Product Change Notification

Change Title	SATA 3SE/3ME/3SE3/3ME3/3IE3/3TE7/3IE7 add packaging factory of controller for better productivity	Date	2021/11/23	PCN No	F2151
PCN level:	Minor				
Models:	SATA 3SE/3ME/3SE3/3ME3/3IE3/3TE7/3IE7				
Category:	Others - Package

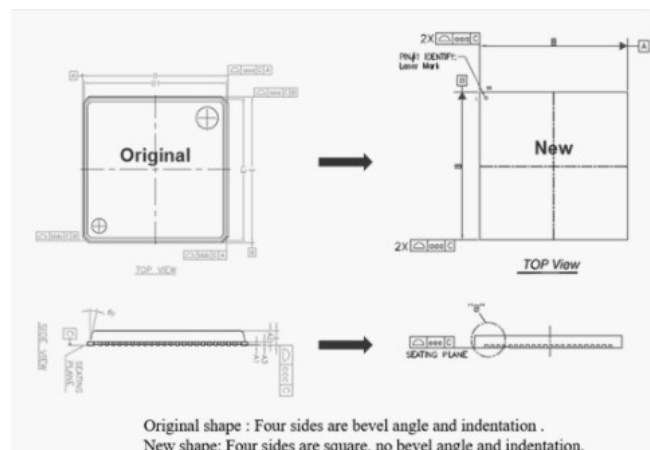
There is different appearance of controller marking and four sides angle to distinguish different packaging factory. Varying work order number on marking correspond to the different packaging factory for SATA 3SE/3ME/3SE3/3ME3/3IE3/3TE7/3IE7 series. Besides, there is a different shape of controller from new packaging factory in SATA 3SE/3ME/3SE3/3ME3/3IE3 series.

- Original controller: Four sides are bevel angle and indentation.
- New controller: Four sides are square, no bevel angle and indentation.
